SERVICE BULLETIN

CHECKING ECCENTERS AND FUEL PUMP PLUNGERS FOR ROTAX_® ENGINE TYPE 912 (SERIES) SB-912-049

MANDATORY

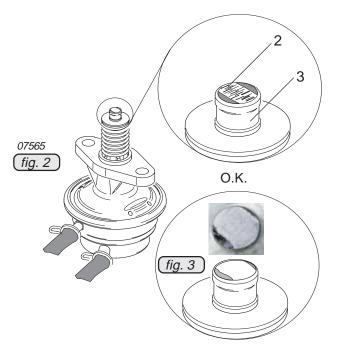
- If OK, then reinstall fuel pump with a new gasket.
- Check the magnetic plug for increased metal content. See Fig. 1.

Steel chips in small quantities as shown in Fig. 1 are acceptable as long as the layer thickness is less than 3 mm. If the findings are unclear, the oil circuit must be flushed and a new oil filter installed.
